ND-2011-0066
December 9, 2011

Subject: PSEG Early Site Permit Application
Docket No. 52-043
**Supplemental Response to Request for Additional Information, RAI
No. 39, Probable Maximum Surge and Seiche Flooding**

RESPONSE to RAI No. 39

PSEG Power, LLC PSEG Site ESPA Part 2, RAI No. 39
Theoretical Wind Setup Diagram
FIGURE RAI 39-8-1 Rev. 0

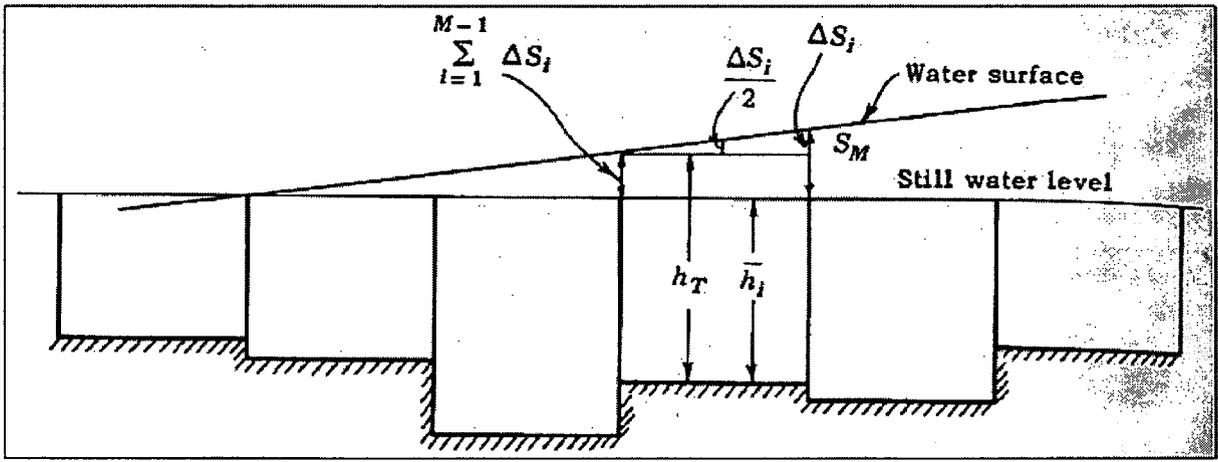
To meet the requirements of GDC 2, 10 CFR 52.17, and 10 CFR Part 100, estimates of the probable maximum hurricane (PMH) and the probable maximum storm surge are needed. The storm surge induced by the PMH can be estimated as recommended by Regulatory Guide 1.59, supplemented by current best practices. SSAR Section 2.4.5.2.2.3 discusses application of the Kamphuis wind setup model to estimate wind-induced water level changes from the mouth of Delaware Bay (developed by the Bodine model) to the project site approximately 80 km (50 miles) inland. The NRC staff requests that PSEG provide the model setup and input conditions applied to develop the wind-induced water level changes from the mouth of Delaware Bay to the project site. The NRC staff requests that PSEG provide information related to any additional analysis completed to understand how the shape of Delaware Bay would influence wind-induced water level changes in the bay.

Calculation of the wind setup is performed by numerically integrating the one-dimensional solution presented in Equation (RAI 39-8-1). A straight line fetch is generated and the depth is recorded at 10 meter intervals. Therefore, the numerical solution steps along the fetch, calculating the surge due to wind setup at every 10 meters, based on the depth at that point plus the surge of the previous step. Figure RAI 39-8-1 conceptually illustrates the wind setup geometry and procedure.

The Kamphuis wind setup model determines the steady state slope of the water surface under steady winds. Hydrostatic pressure gradient balances the countering forces imposed by the steady wind stress. As shown by Equation (RAI 39-8-1), the slope of the water surface is greater in shallow water bodies. Variation in depth, a feature of the shape of the water body, affects the wind setup calculation.

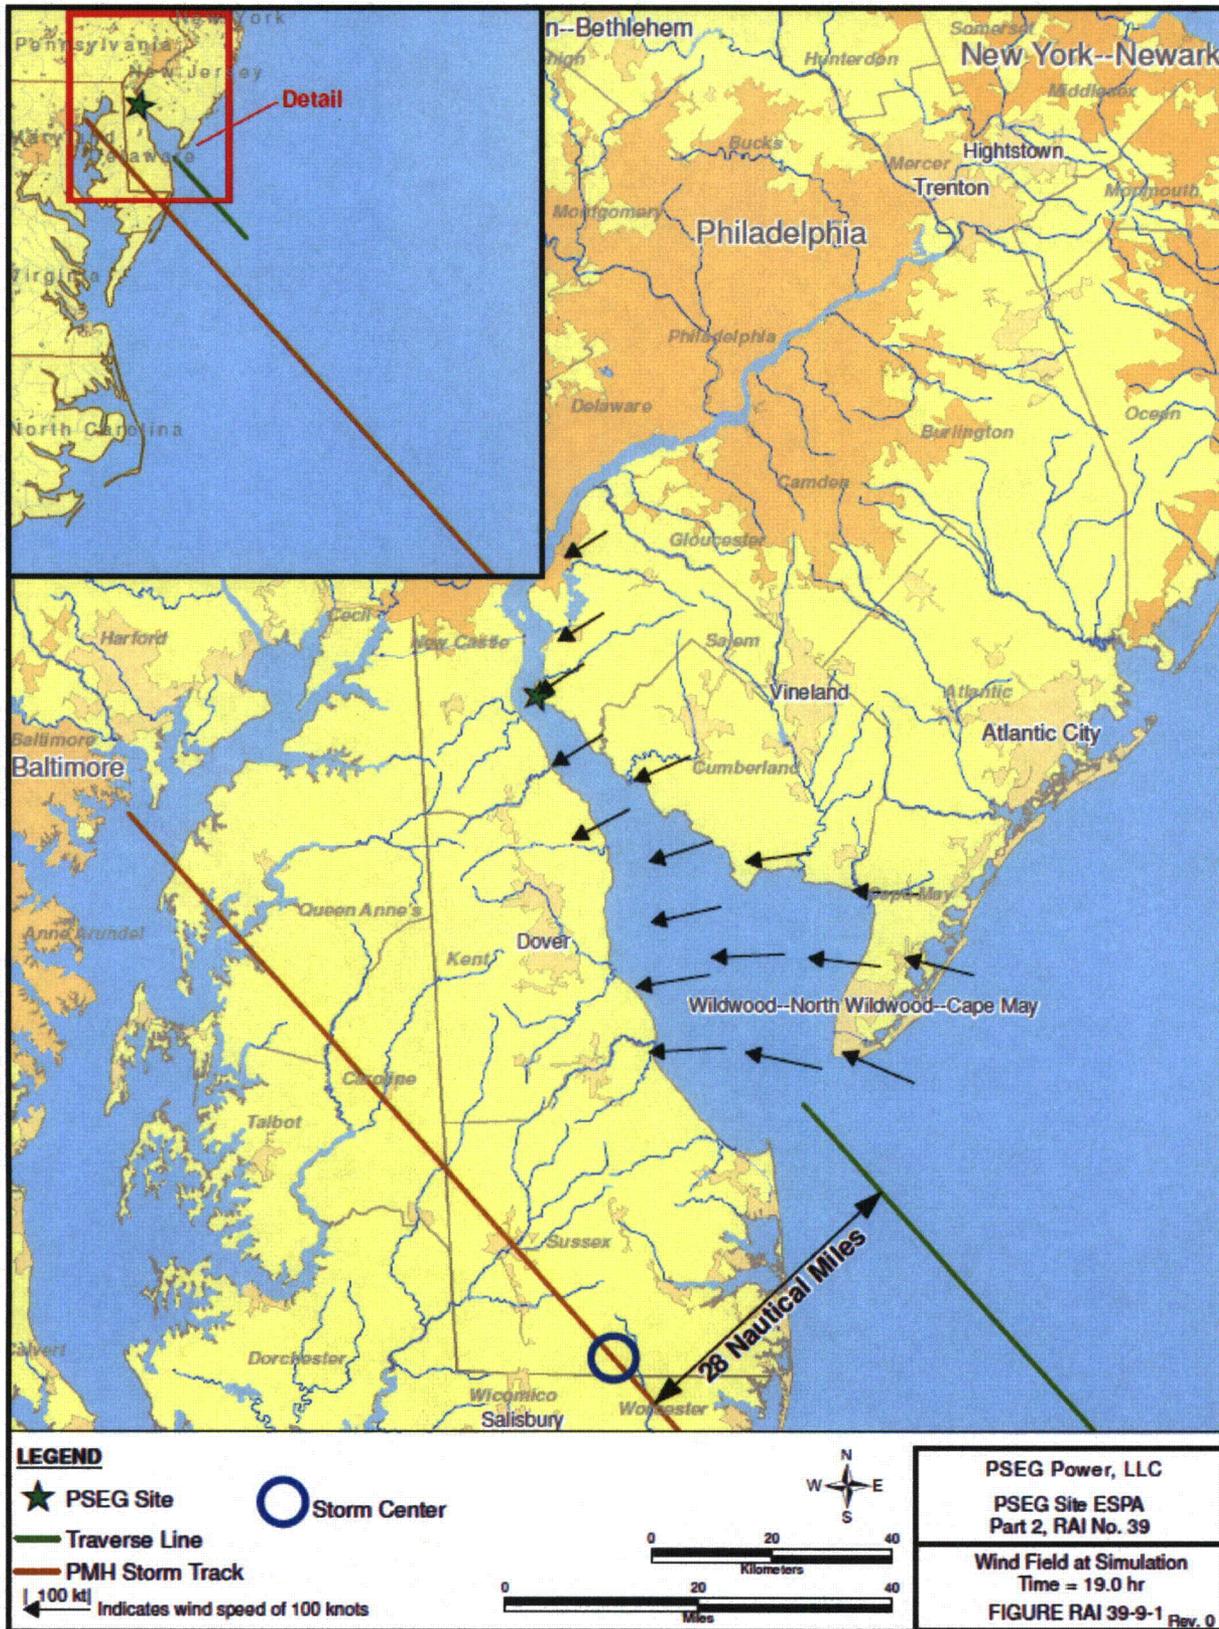
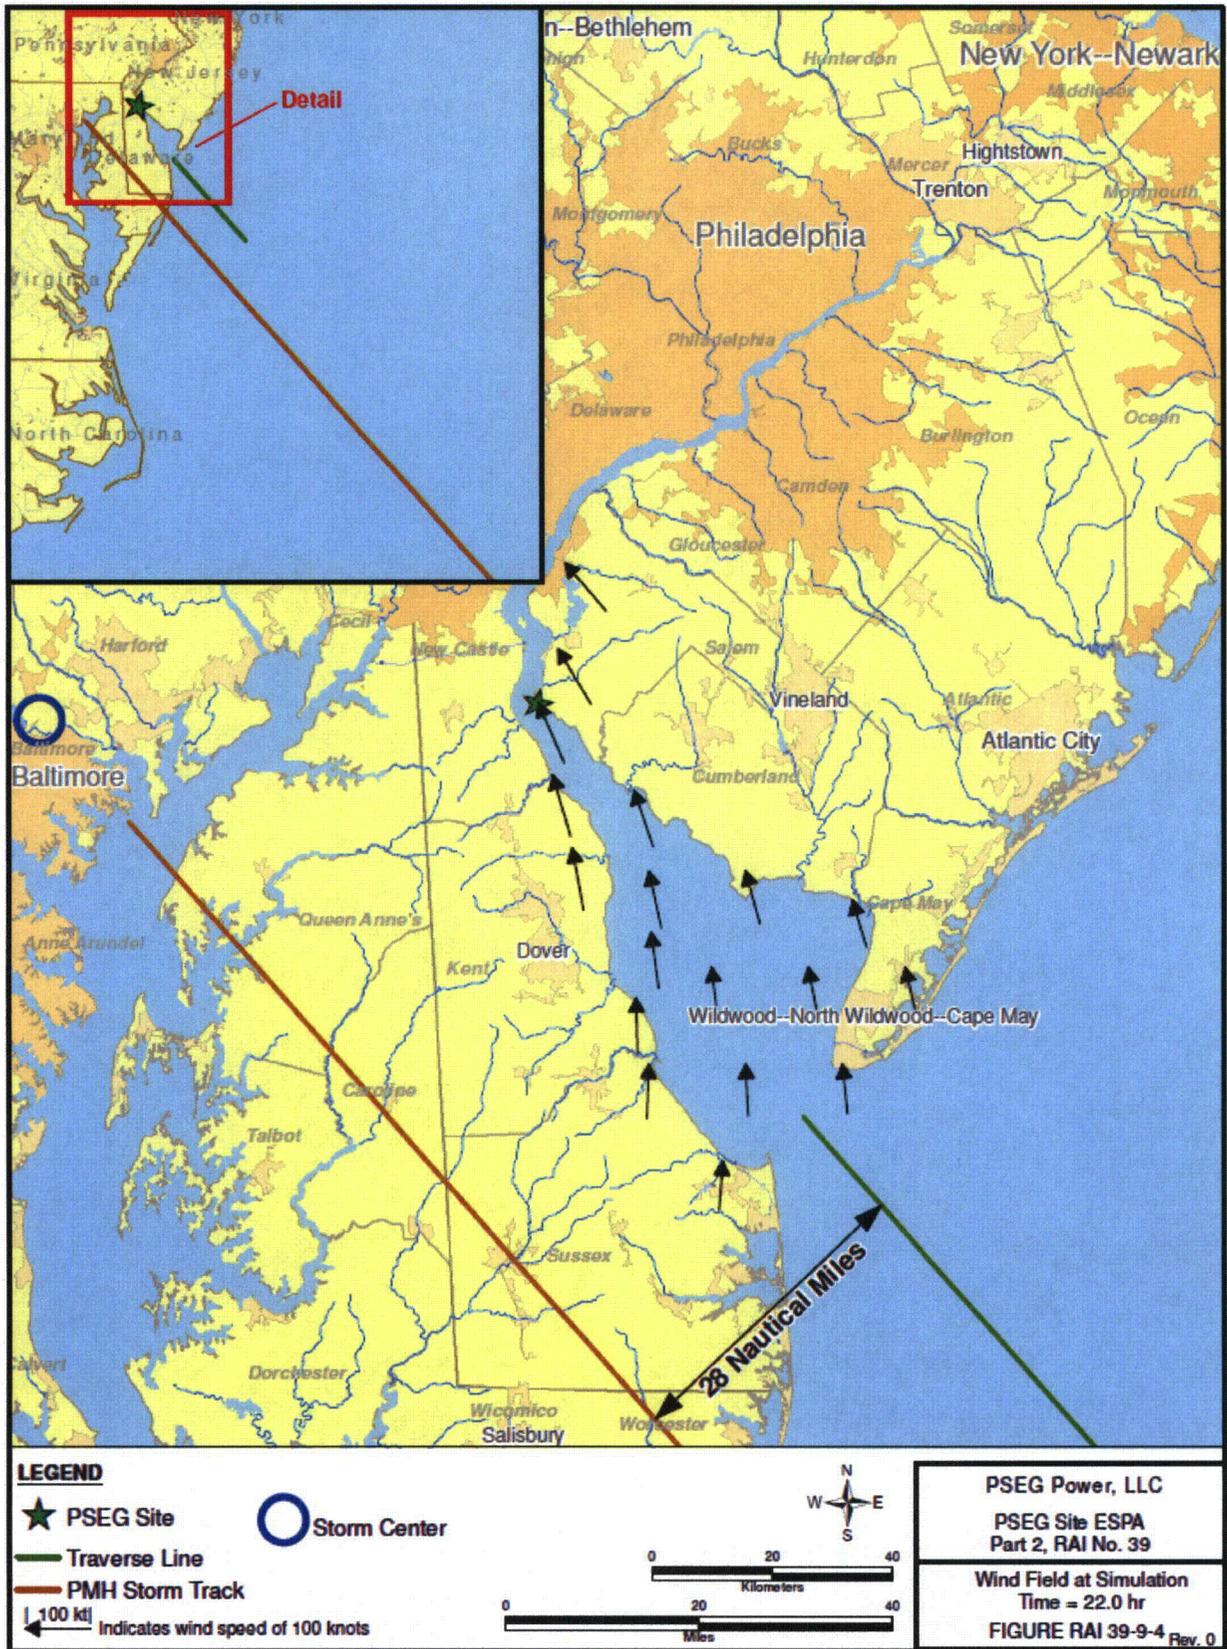
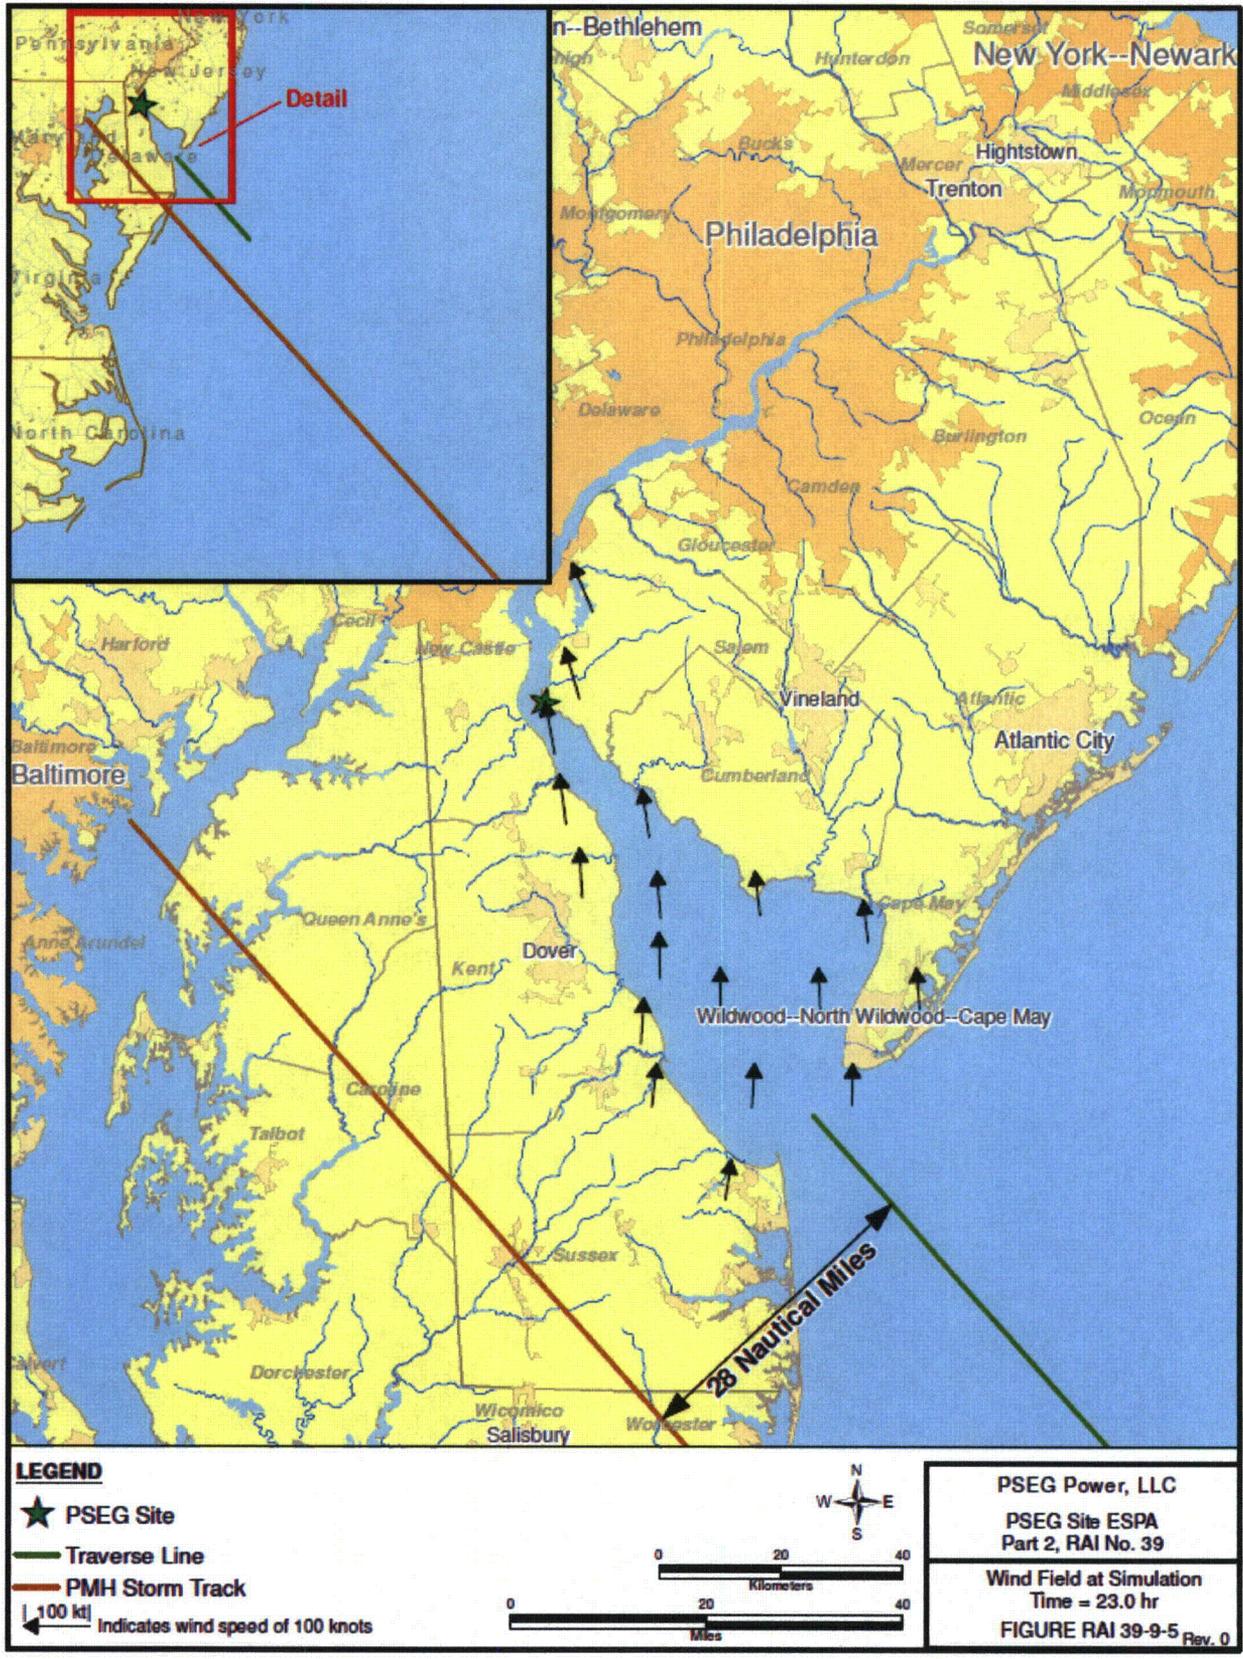
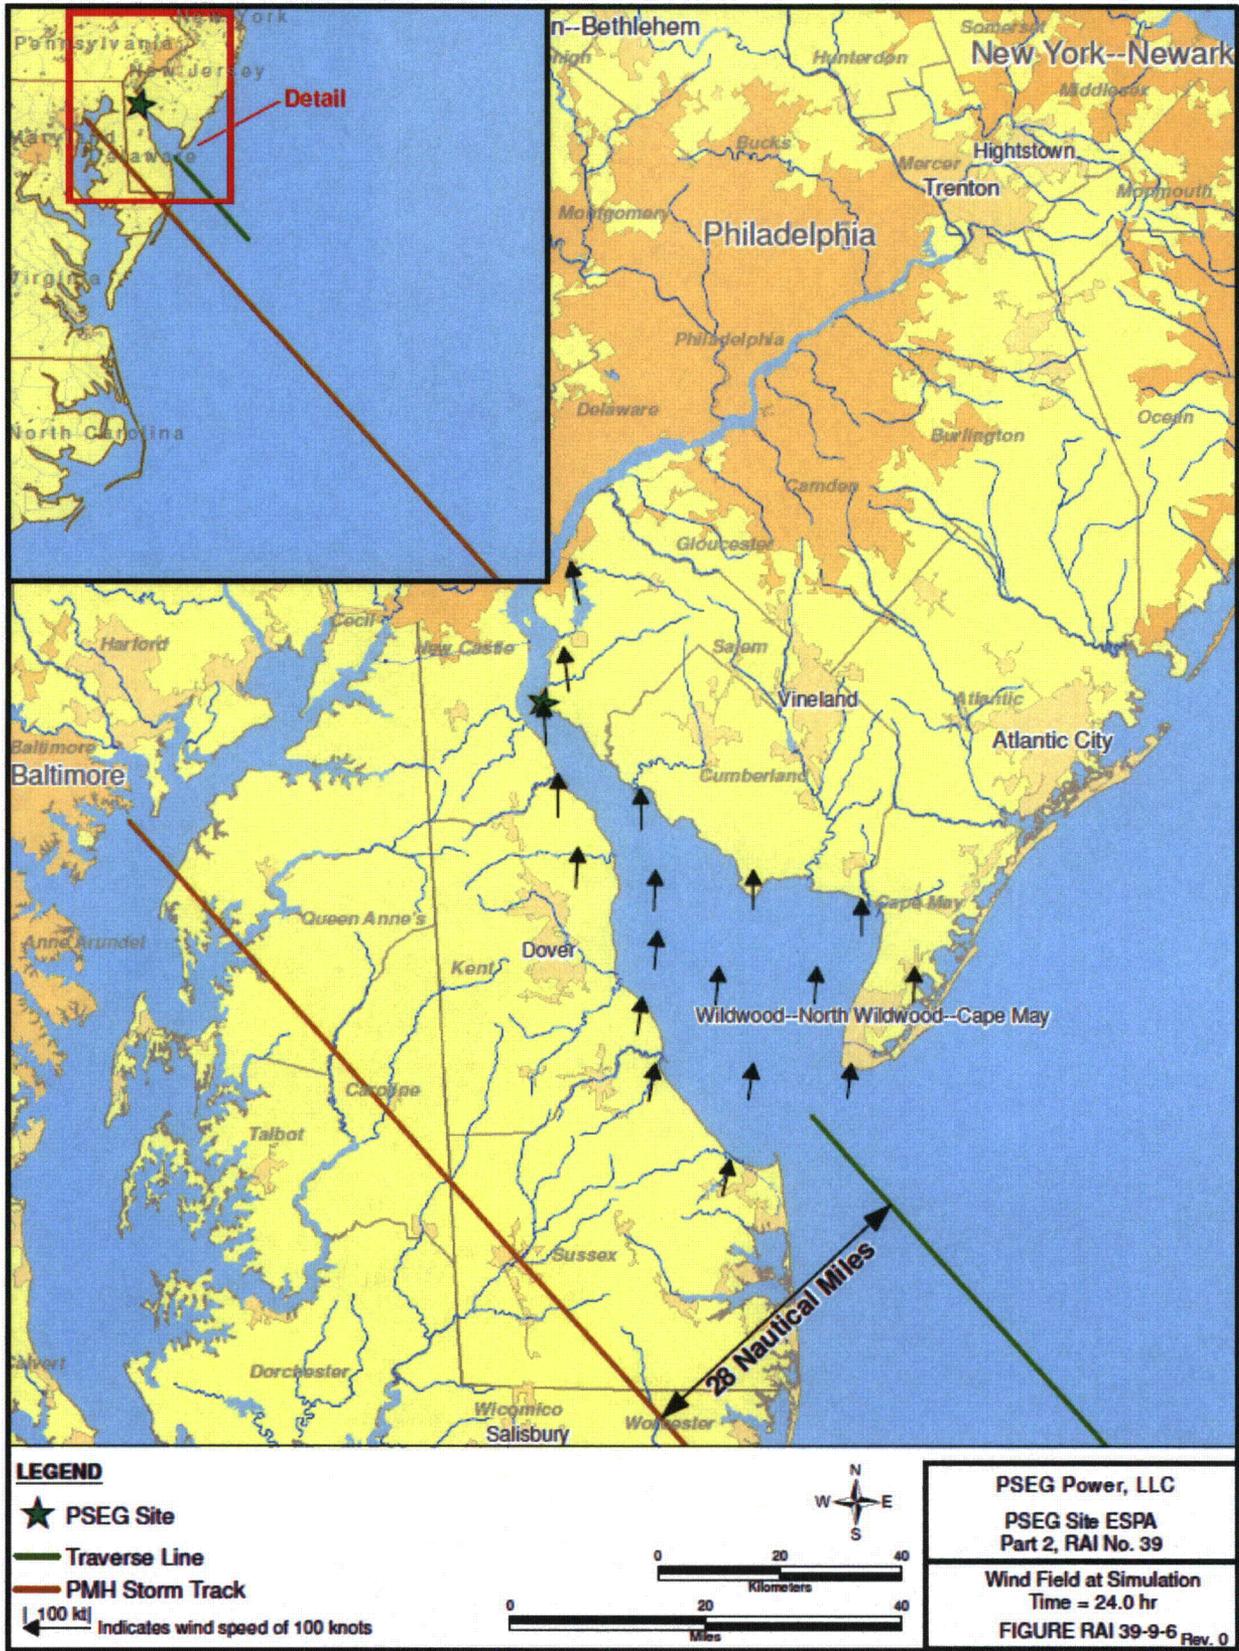
To meet the requirements of GDC 2, 10 CFR 52.17, and 10 CFR Part 100, estimates of the probable maximum hurricane (PMH) and the probable maximum storm surge are needed. The storm surge induced by the PMH can be estimated as recommended by Regulatory Guide 1.59, supplemented by current best practices. SSAR Section 2.4.5.3.1 discusses the development of the wave runup at the project site. The NRC staff requests that PSEG provide plots that illustrate the wind vector directions and magnitudes at the time of, and at several times before and after, maximum PMH surge. NRC staff also requests that PSEG provide wave runup estimates at the proposed project site for these times.

Wind vectors throughout Delaware Bay, including some areas that may be inundated during the PMH surge, are provided in Figures RAI 39-9-1 through RAI 39-9-6 for simulation times 19.0, 20.0, 21.0, 22.0, 23.0, and 24.0 (hr). Wind vectors were calculated in accordance with NOAA NWS 23 (SSAR Reference 2.4.5-18). The ends of the lines nearest the arrows are the points at which the winds were determined. The lengths of the vectors are proportional to the wind speed.
